000 91 13.2 – ADDENDUM NO. 2

- A. Project Name: Pacific Building Conversion
- B. Owner: Kitsap County Department of Human Services
- C. Architect: Rice Fergus Miller, Inc.
- D. Architect Project Number: 2021056.01
- E. Date of Addendum: November 29, 2023

VENTING UPDATED TO MATCH P22.00 WASTE ROUTING.
FLOOR SINKS ADDED TO KITCHEN

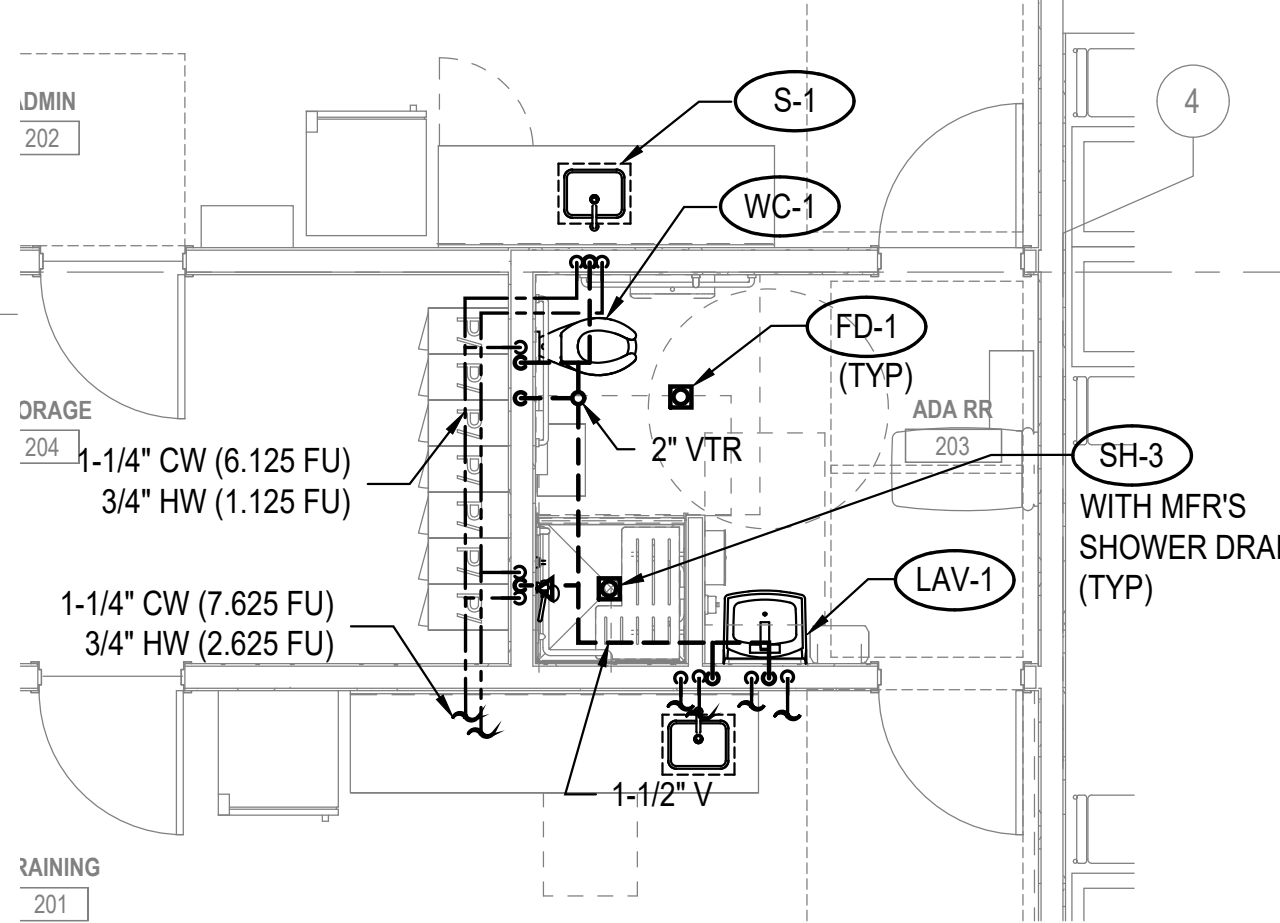
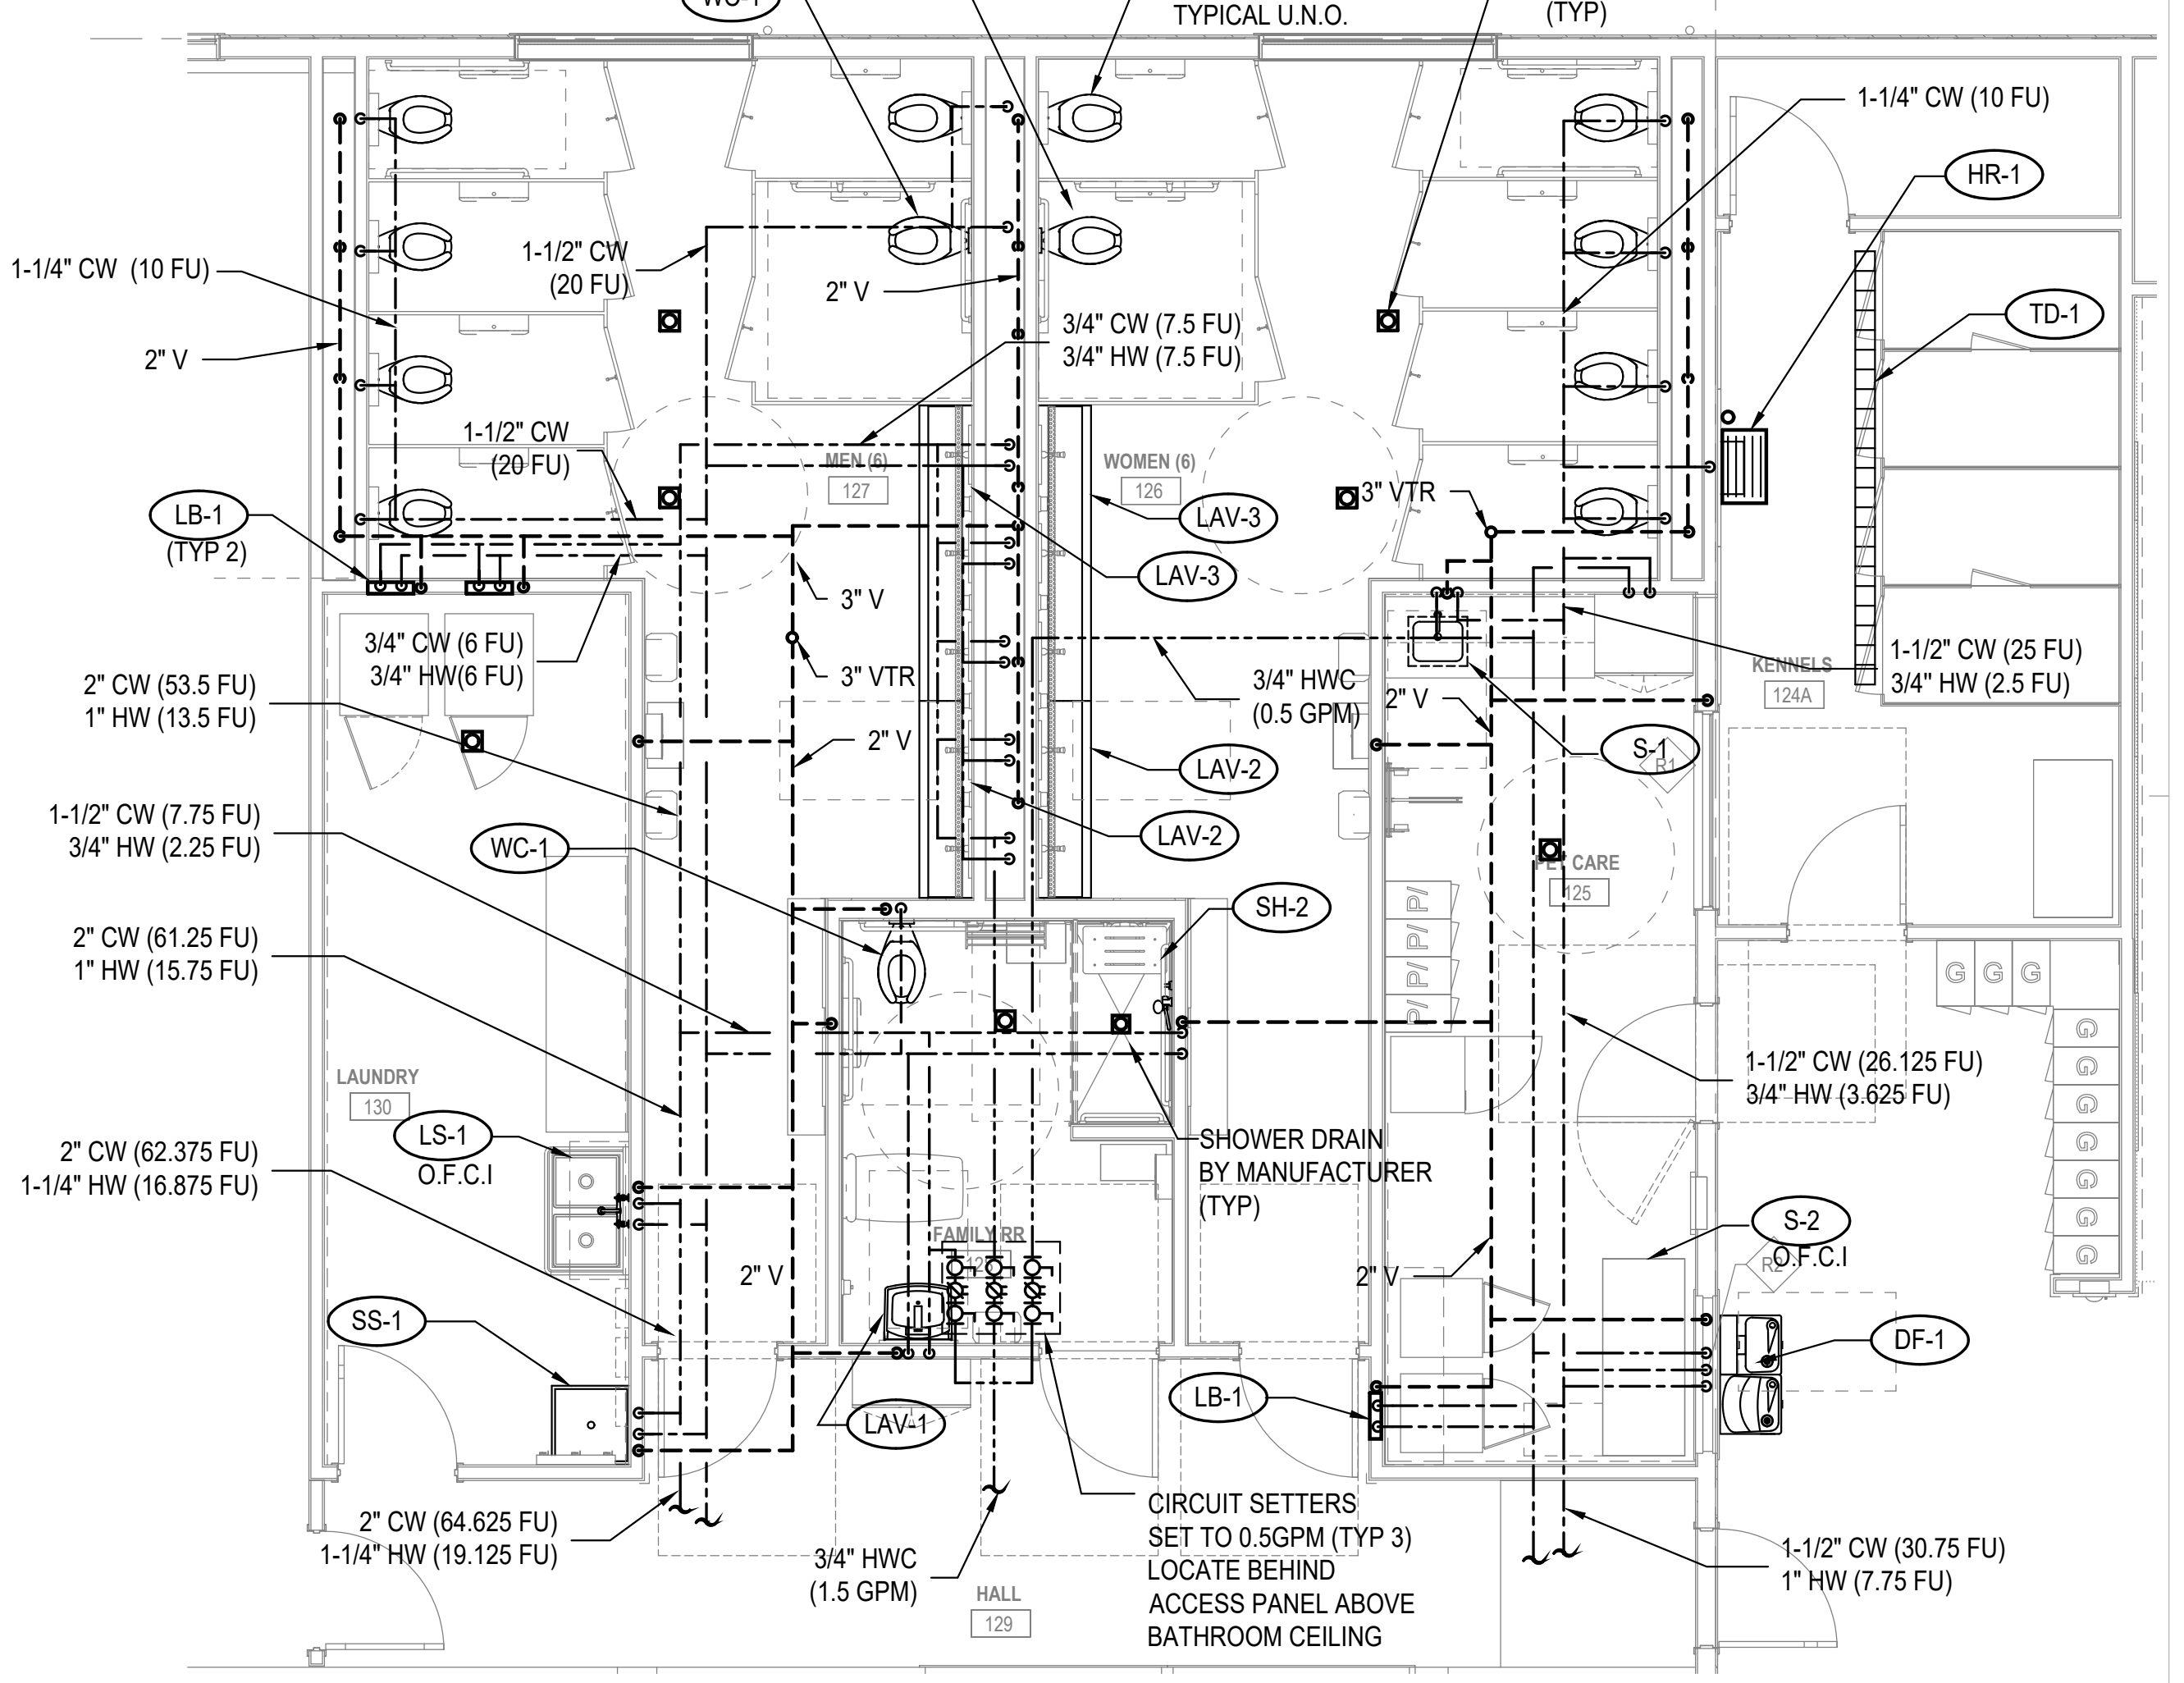
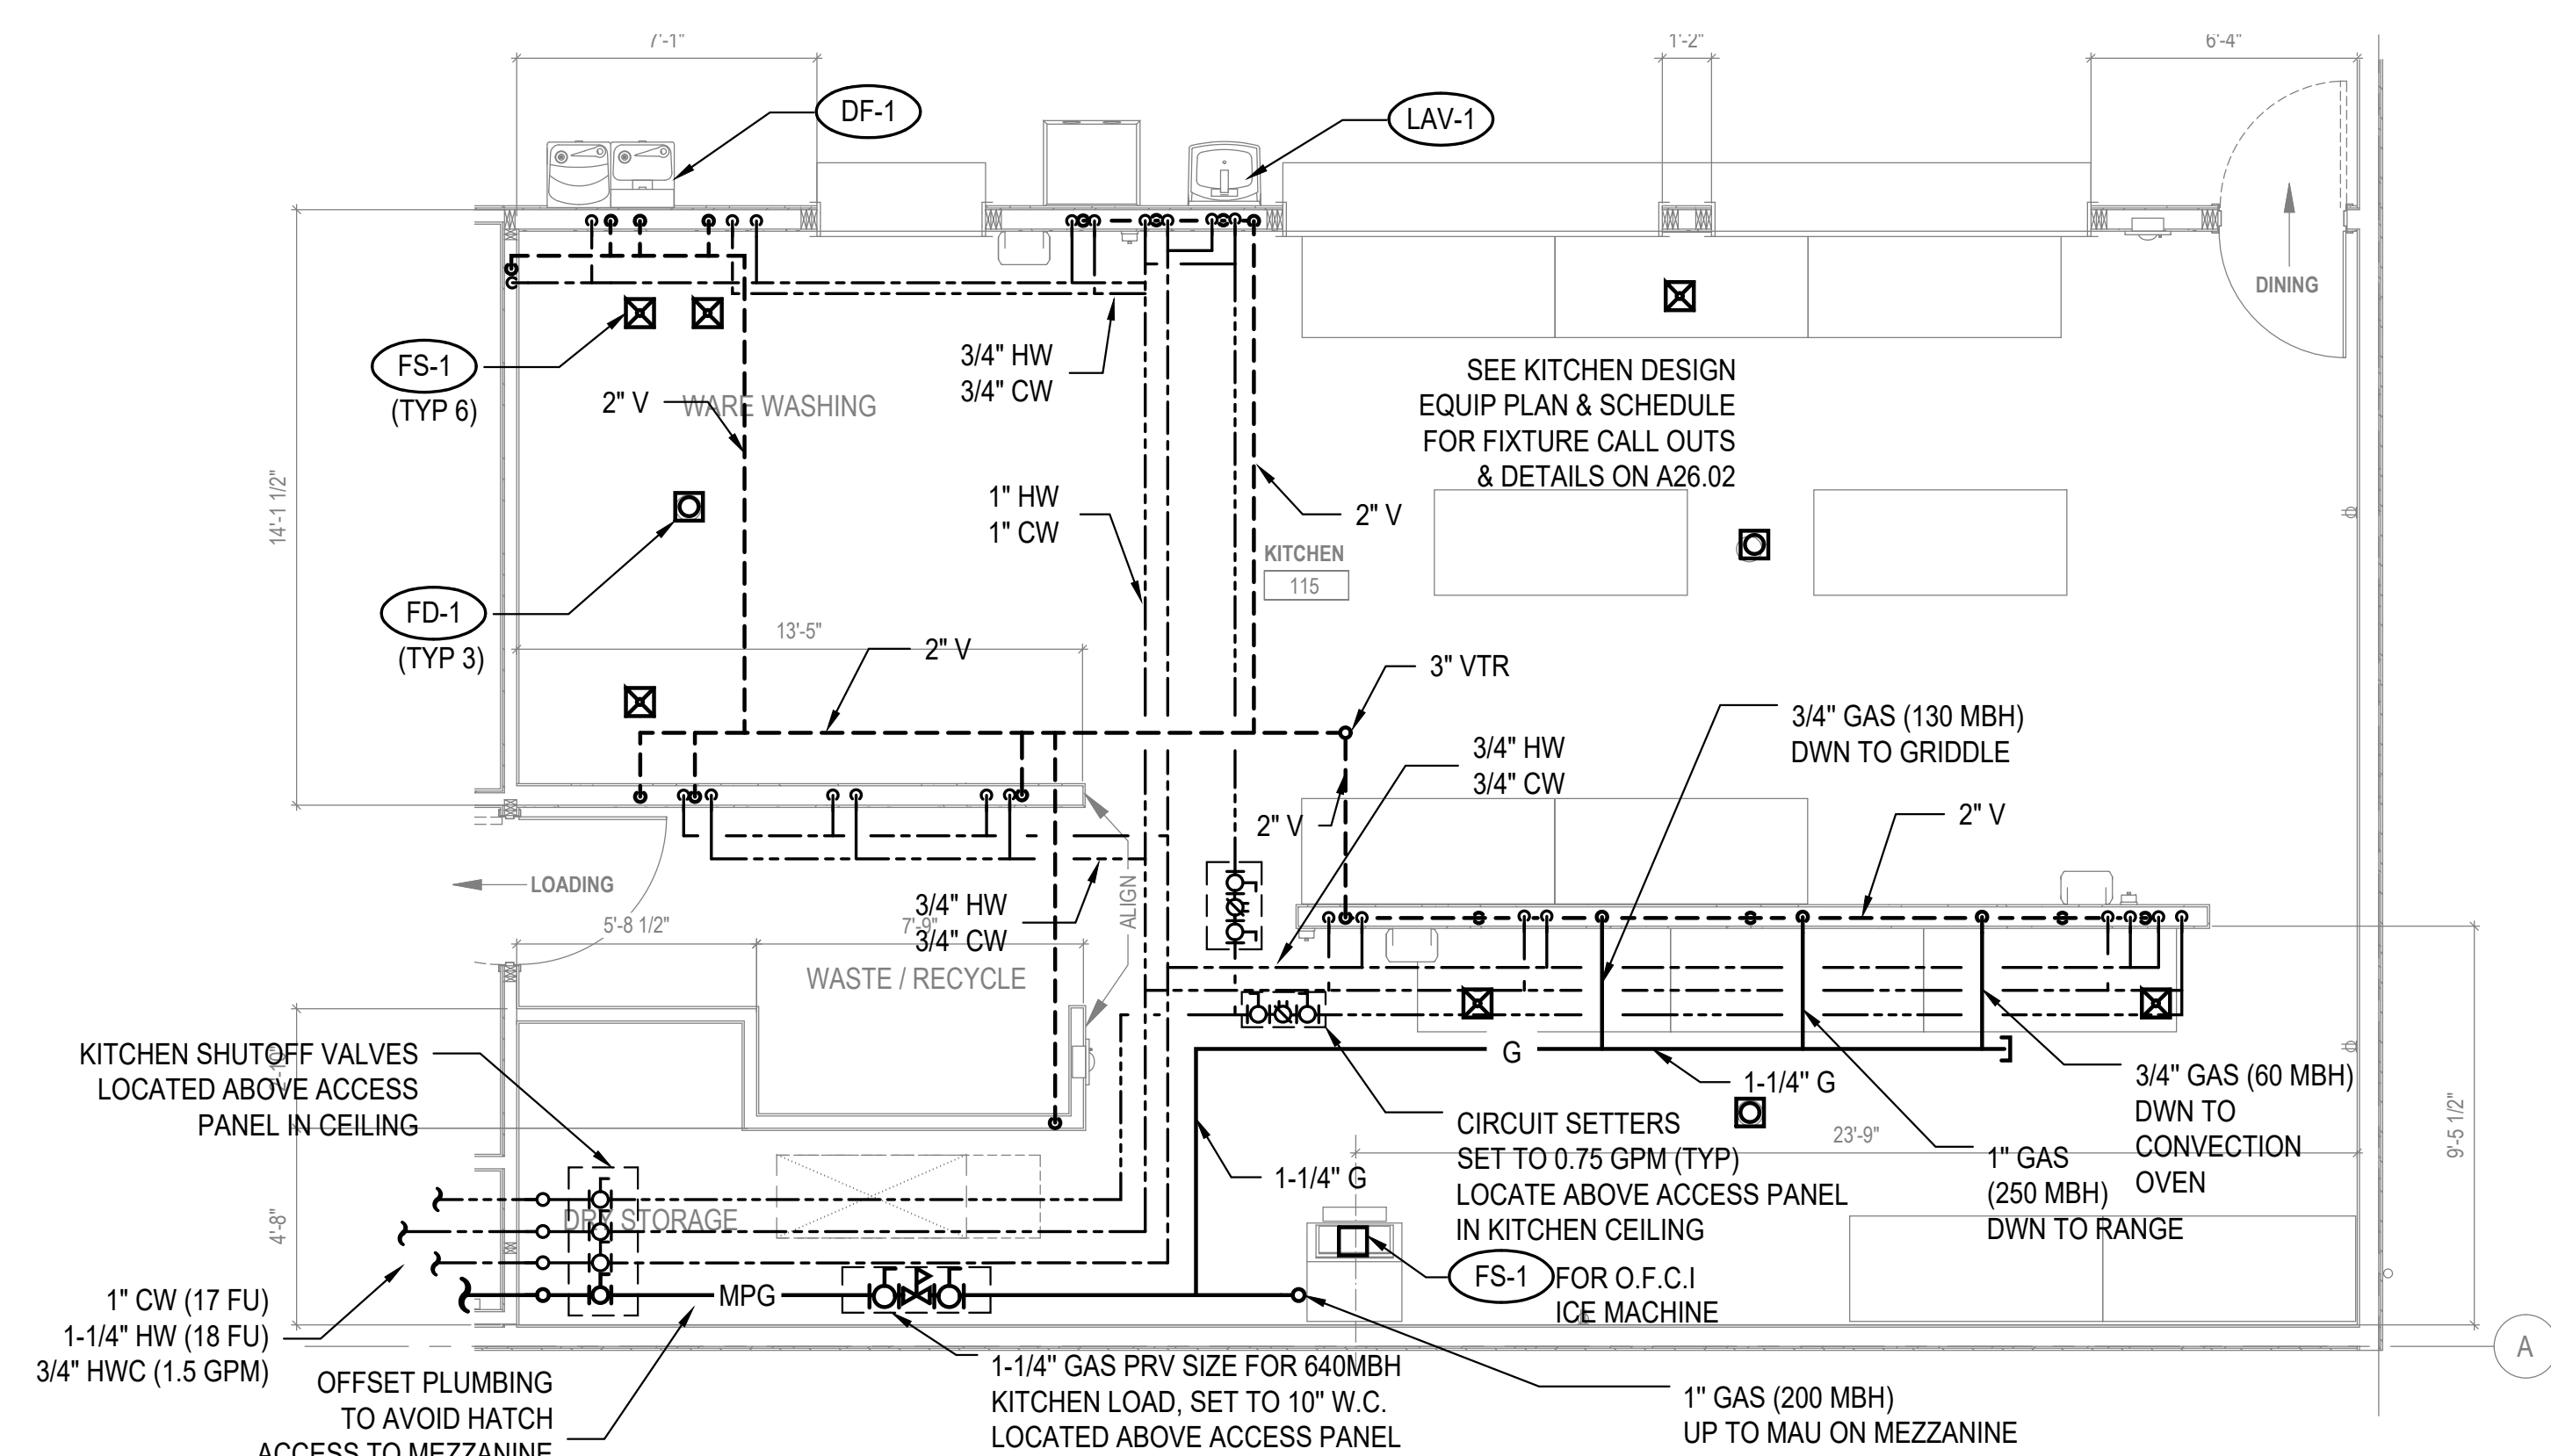
- a. Waste and vent routing updated. Floor sinks added to the kitchen.
- ITEM 17. Sheet P23.01 – Venting updated to match underground.
- ITEM 18. Sheet E00.03 – REPLACE in its entirety:
